APPENDIX C6:
Comments Received

Comments received during EIAr Review and
Comment period

COMMENTS ON THE DRAFT ENVIRONMENTAL IMPACT ASSESSMENT REPORT FOR THE PROPOSED KOTULO TSATSI ENERGY PV1 FACILITY IN THE NAMAKWA DISTRICT MUNICIPALITY, NORTHERN CAPE PROVINCE

**COMMENT: EIA REPORT KOTULO TSATSI SOLAR DEVELOPMENT PROJECTS; PV 1:
ENVIRONMENTAL IMPACT ASSESSMENT AND PUBLIC PARTICIPATION PROCESS**

Figure 1: Van der Merwe vulture count of 102 birds on pylons in February 2021; position in circled area.

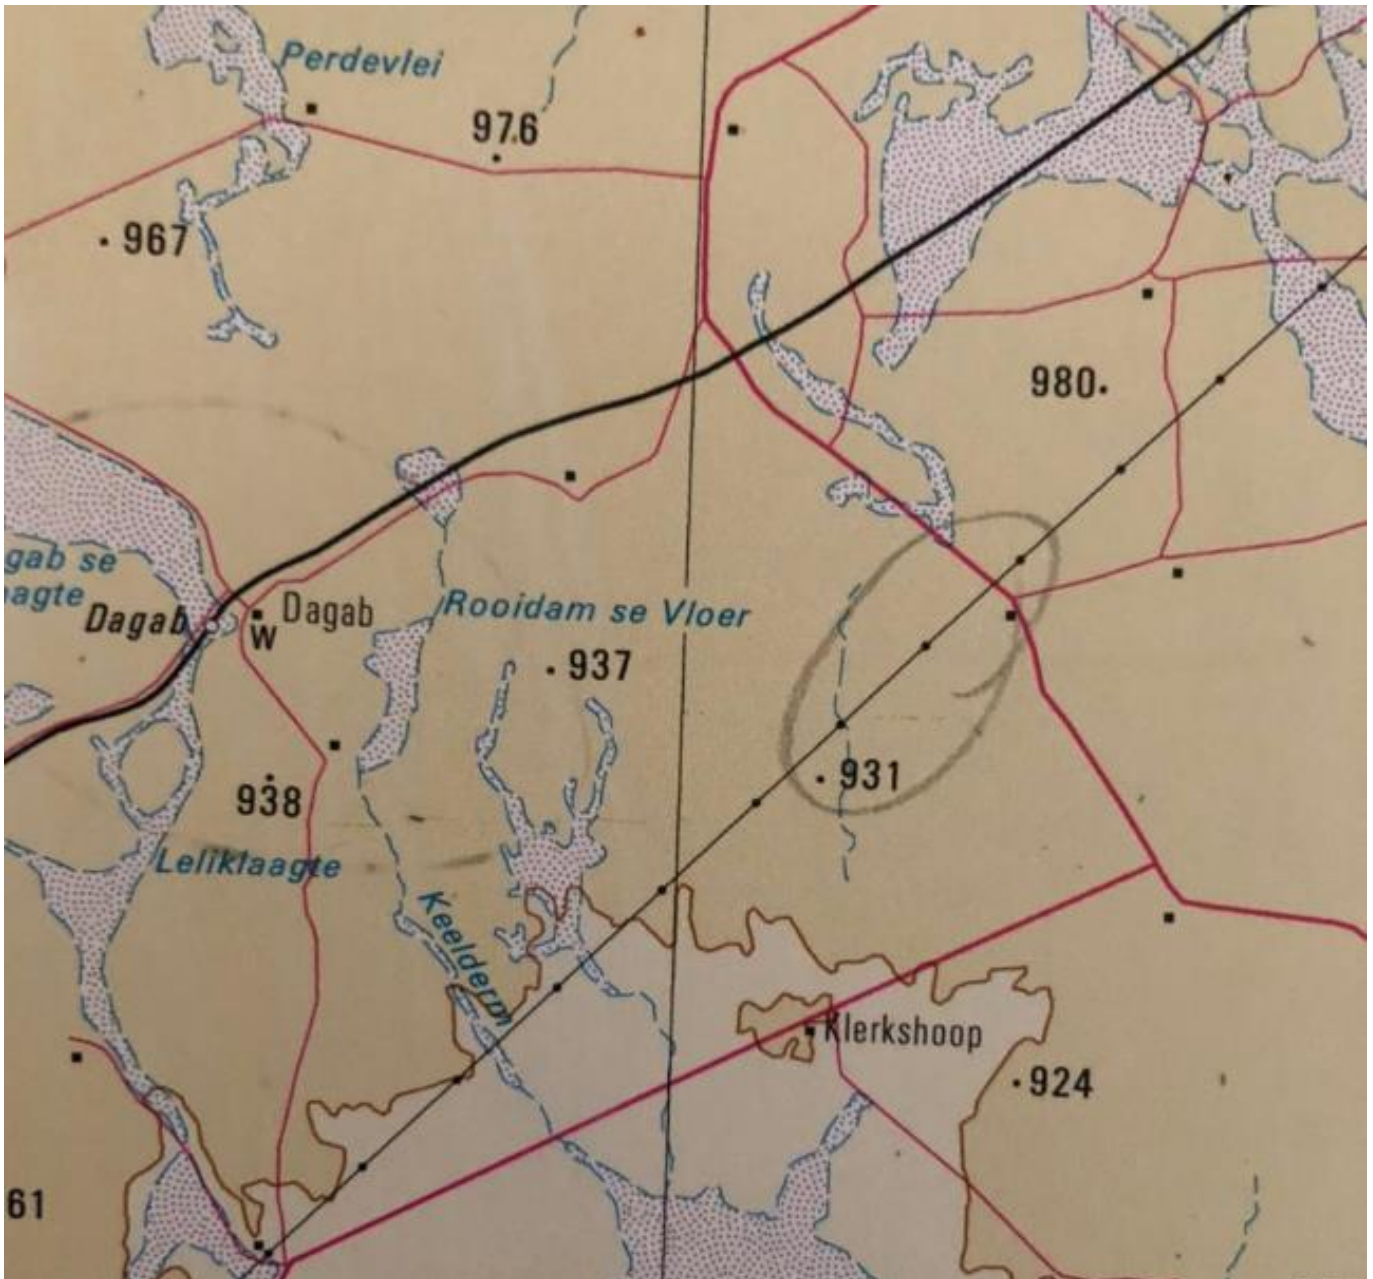
Van der Merwe counted 102 vultures at the end of February 2021 on the pylons right in the middle of the Kotulo Tsatsi Solar Reserve, please refer to Figure 1 in this regard. As such the development area proposed for PV1 and the associated infrastructure like transmission lines to the Eskom substation will negatively affect these birds directly.

Figure 1: Savannah Source Map ; NDM ESA (macro regional corridor) between turquoise lines and "observed" during the previous EIA as hashed grey.

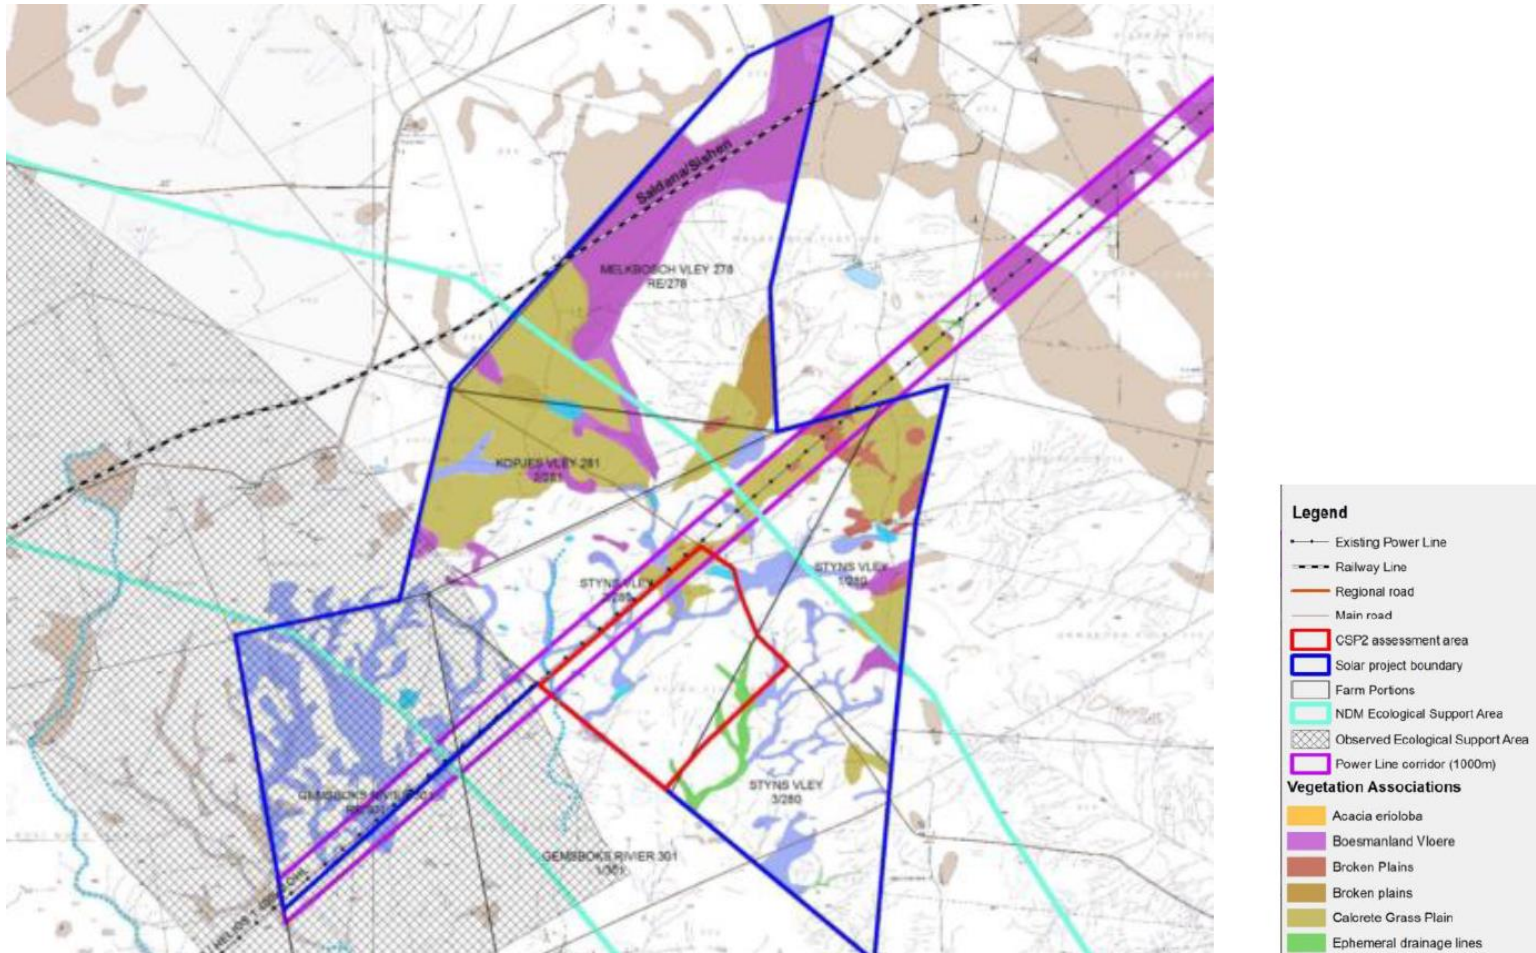
DEFF should take note how this regional corridor that runs through the middle of the site was initially ignored when the 55 000 ha site was selected for the development of a Solar reserve only to be changed as an observed corridor. Again it emphasis our reasoning that the natural environment did not receive priority in site selection, and the EIA is just an administrative process that the applicant is going through. The consultants at a very late stage became creative through micro analysis and "moved" the ESA south, to conveniently exclude the preferred development footprint from the corridor and to unlocking the potential for further solar farm develop in the Solar reserve area. Now the vultures have been observed right in the middle of this corridor isn't it ironic?

Figure 2: Source - SEA www.csir.co.za & DEA

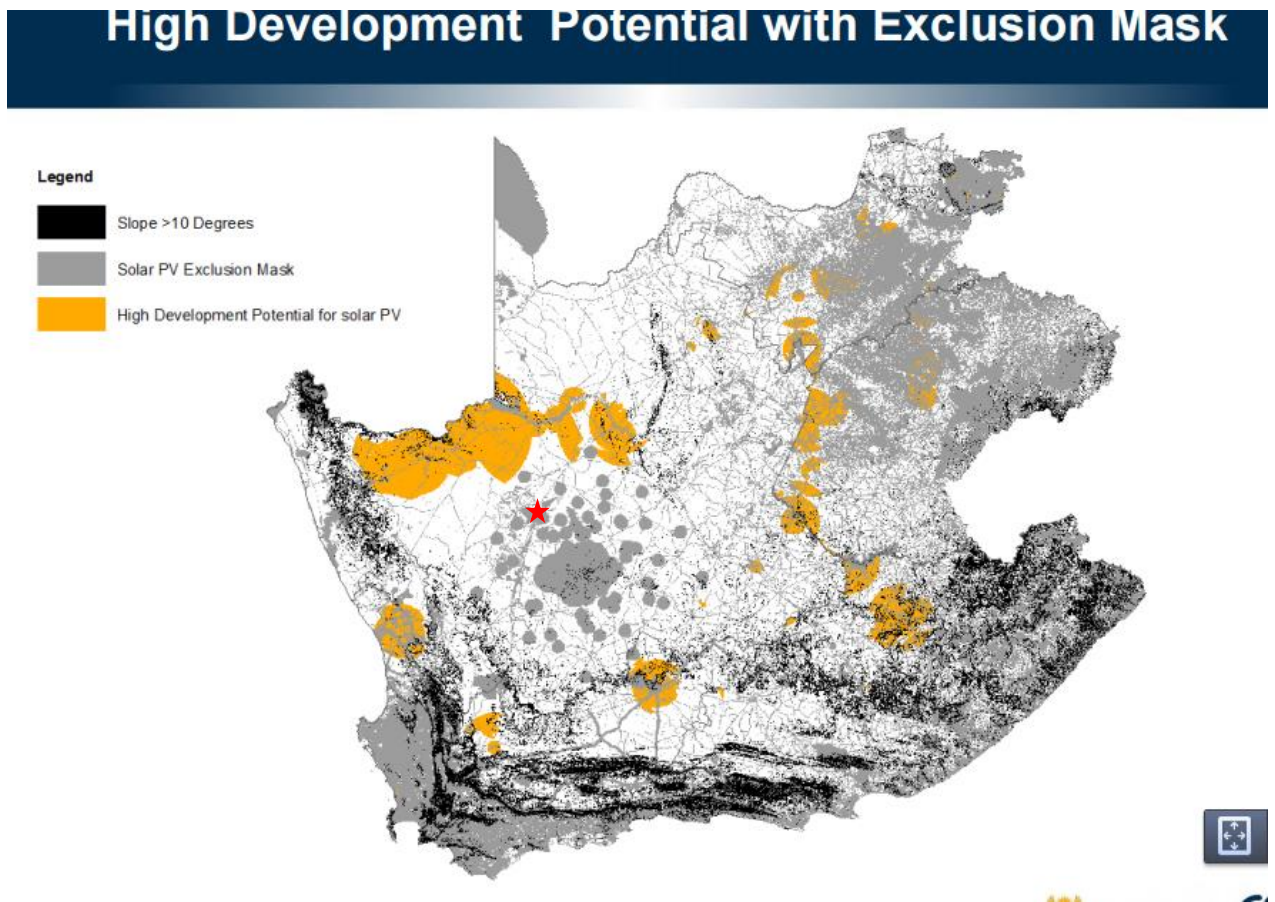
Below is a map extracted from the CSRI & DEA SEA, the red star is the approximate location of the proposed PV1. It is clearly outside of high development potential areas and within an exclusion area.

Figure 1: Source - SEA www.csir.co.za & DEA

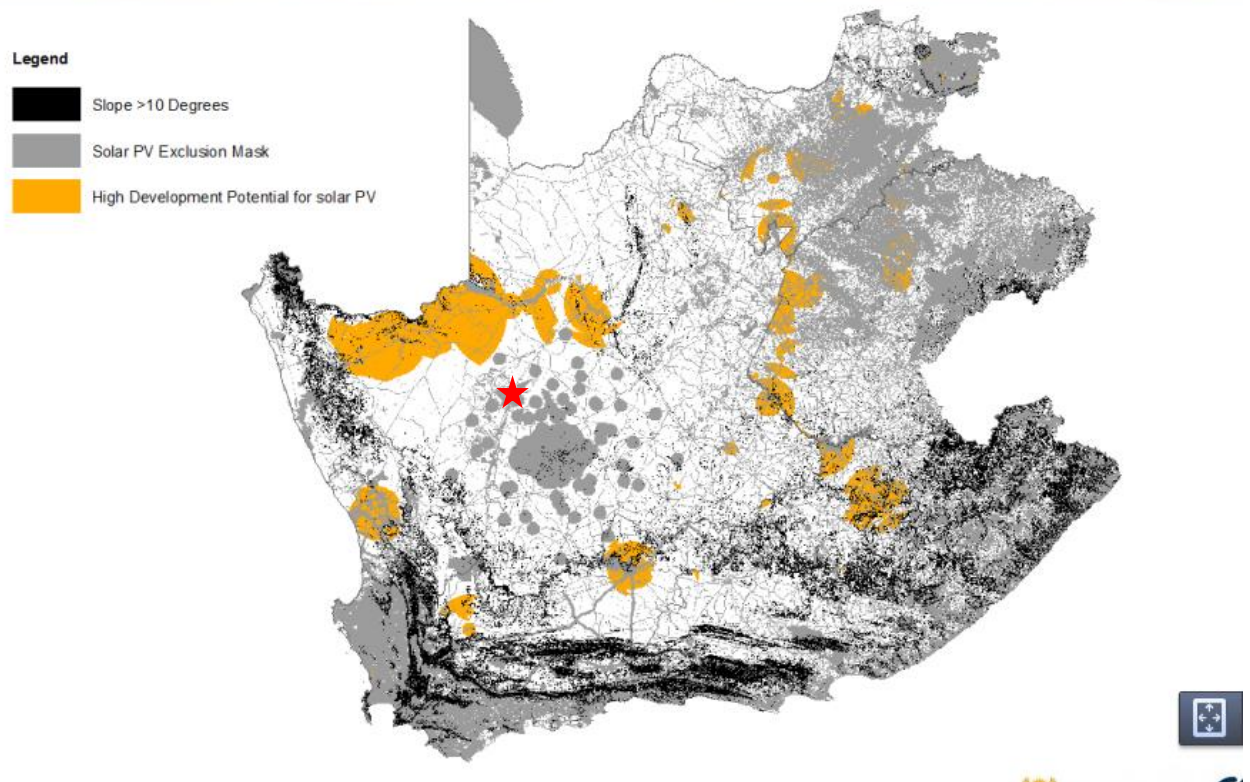
Below is a map extracted from the CSRI & DEA SEA, the red star is the approximate location of the proposed PV1, PV2 & PV3. It is clearly outside of high development potential areas and within an exclusion area. The grey exclusions in this case relate to SKA reserve area, sensitive wetland drainage patterns and ecological corridors.

Figure 3: SKA Astronomy Reserve

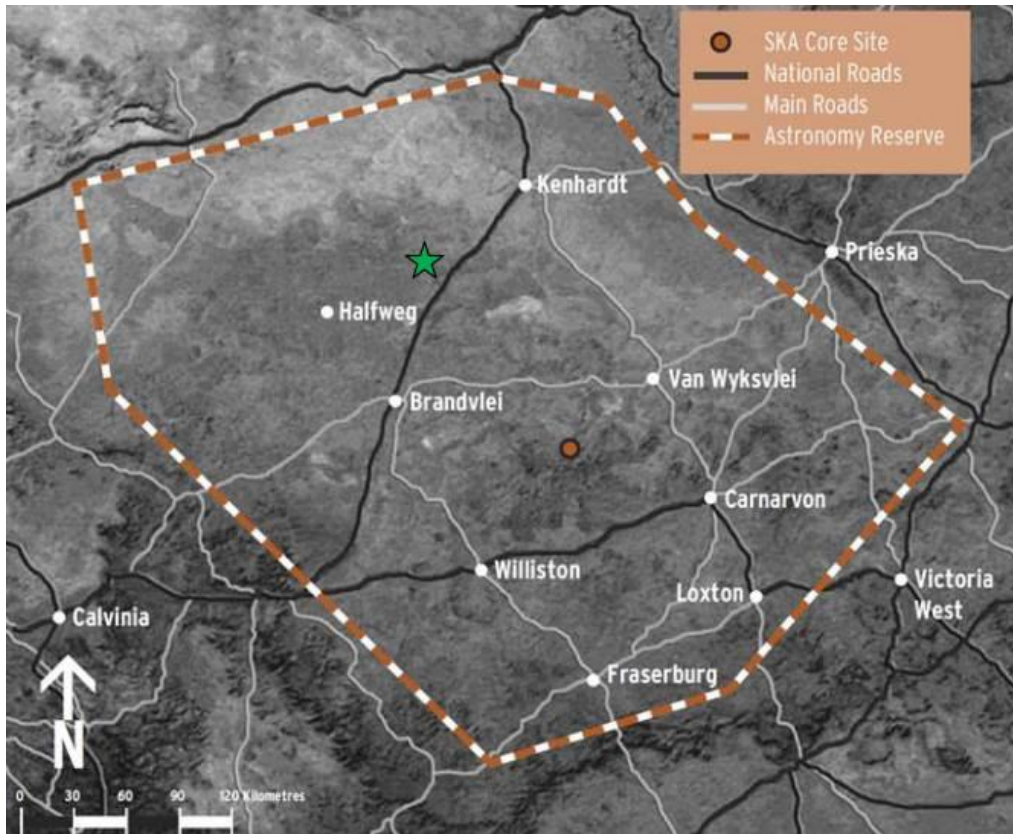
Figure 2 below is extracted from the CSRI & DEA SEA. It illustrates the Pofadder potential development area in relation to the approved site (red star). Clearly the site is outside of the area amongst exclusion mask criteria.

We are very concerned that the approach of three separate EIA's is not presenting the full impact of the entire scheme and that the separate EIA's downplay the actual extent. As far as we understand the applications have been split in order for the developer to bid the projects as "stand-alone" projects each with their own EA under the Department of Energy's Renewable Energy Independent Power Producers Procurement (REIPPP) programme.
